**STATE SIGNIFICANT INFRASTRUCTURE  
ASSESSMENT:  
WestConnex Stage 3 – M4-M5 Link  
SSI 7485**

Environmental Assessment Report under  
Section 5.18 of the  
*Environmental Planning and Assessment Act 1979*

March 2018

**Figure 23: Overshadowing assessment of the Iron Cove Link MOC 4 as shown at hourly intervals between the hours of 9:00 am to 3:00 pm on 21 June 2017 (Adapted from Proponent's EIS)**

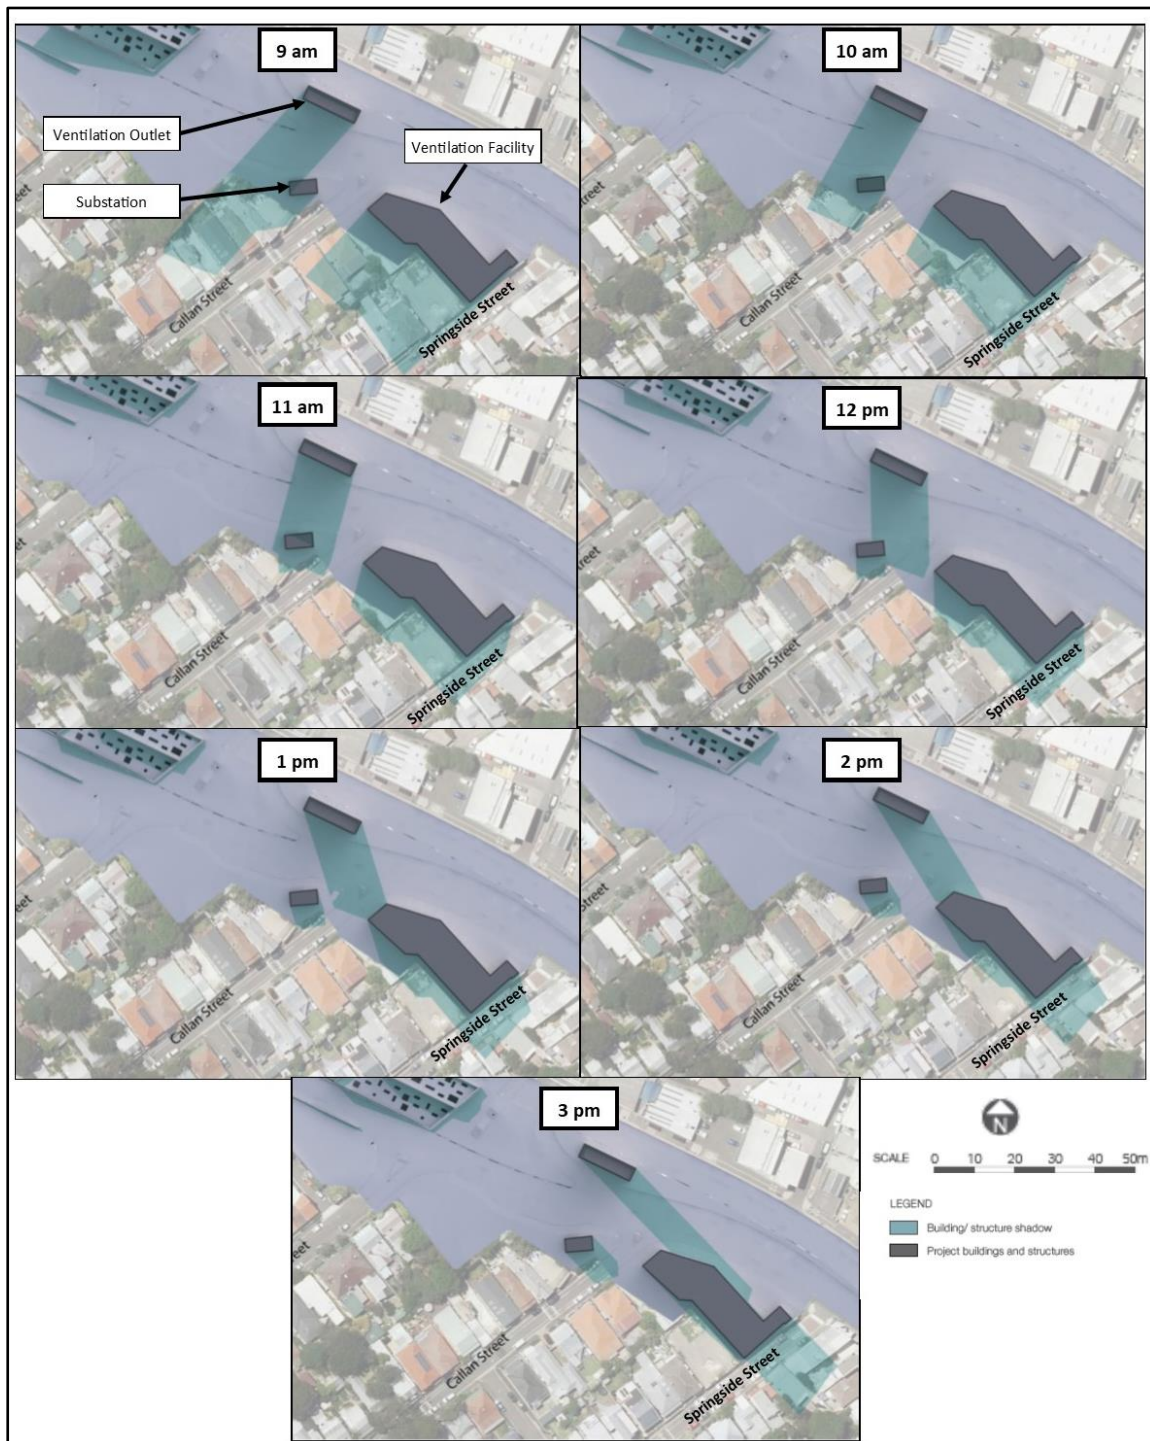
The primary impacts associated with overshadowing are to residential properties located around the ventilation outlet and ventilation facility at Iron Cove, particularly towards the north-eastern ends of Callan and Springside Streets as shown in **Figure 23**. The Department does not consider the loss of five hours of solar access between 9:00 am and 3:00 pm in mid-winter as a result of the project to be an acceptable outcome.

Both the Department's *Apartment Design Guide* and *Draft Medium Density Design Guide* stipulate that overshadowing should be minimised and aim to achieve no less than two hours of solar access between 9:00 am and 3:00 pm in mid-winter. Given the surrounding urban

context of the Iron Cove Link area, the Department considers a more stringent approach than proposed by the Proponent should be taken.

As such, the Department has recommended a condition requiring any infrastructure related to the project be designed and positioned in such a way as to provide solar access to the habitable rooms and at least 50 per cent of principal private open space of any residential property impacted by the project for at least three hours between 9:00 am and 3:00 pm during mid-winter. This is consistent with the infrastructure approvals for the New M5 and M4 Widening. Should the Proponent not be able to meet this condition, alternative mitigation must

Figure 24: Construction sites C5, C6 and C7 within and surrounding Rozelle Rail Yards (Source: EIS)

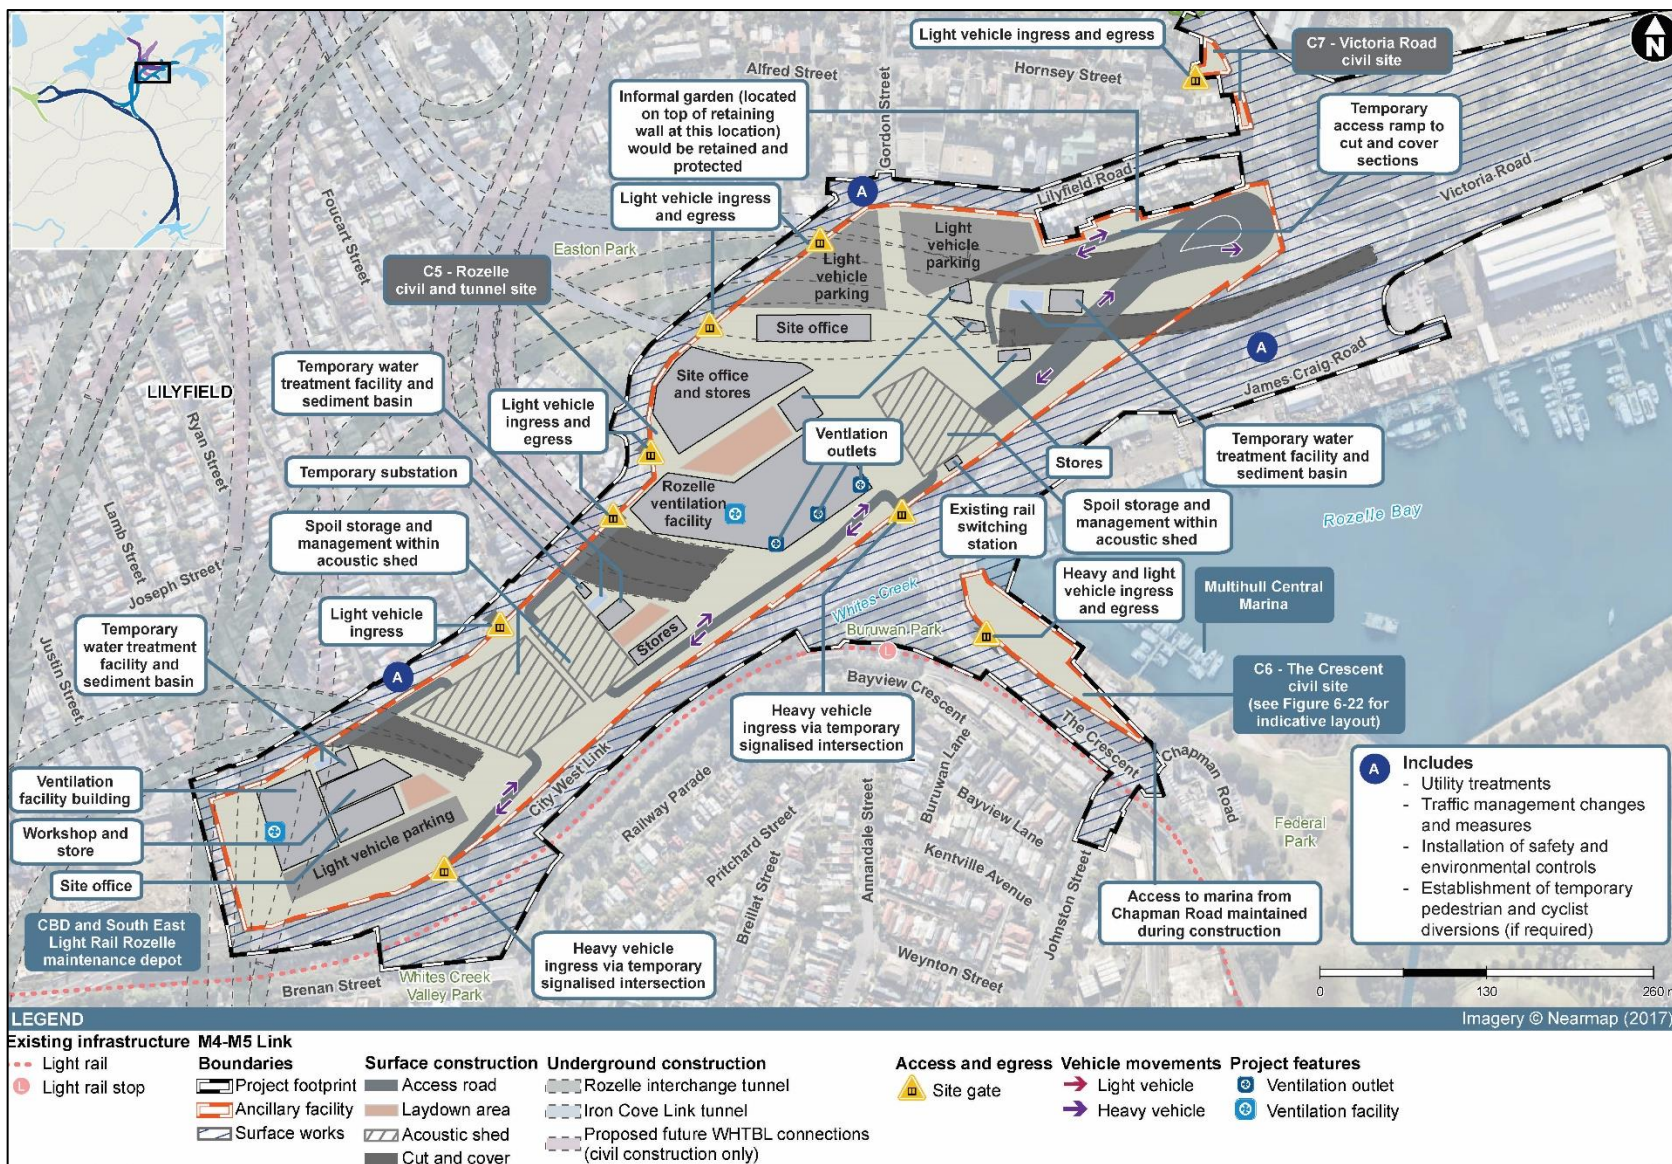
The land at The Crescent Civil Site (C6) (see **Figure 24**), which is currently disused vacant land zoned Waterfront under SREP 26 – City West, will not be required for operations. The land to be used for the construction ancillary facility C7 along Victoria Road has been proposed to be retained and managed under a UDLP. The Department understands that the land at C6 and the land at Rozelle Rail Yards is of importance to the achievement of *The Bays Precinct Urban Transformation Program* (Bays Precinct Program) in which the vast majority of the land and its surrounds, designated Rozelle Bay and Bays Waterways in the Strategy, is considered a medium-term priority. As such, the Department supports the return of land at C6 as residual land following completion of construction.

However, the Department does not consider the land at the C7 Victoria Road Civil Construction Site (see **Figure 24**) should be retained by the Proponent nor should it be managed through a UDLP as pockets of open space. The Department considers, given the development potential at this site, that the land at C7 should be considered residual land (and therefore options such as residential or commercial development could be explored) and treated as such following the completion of construction. The Department has recommended a condition to this effect.
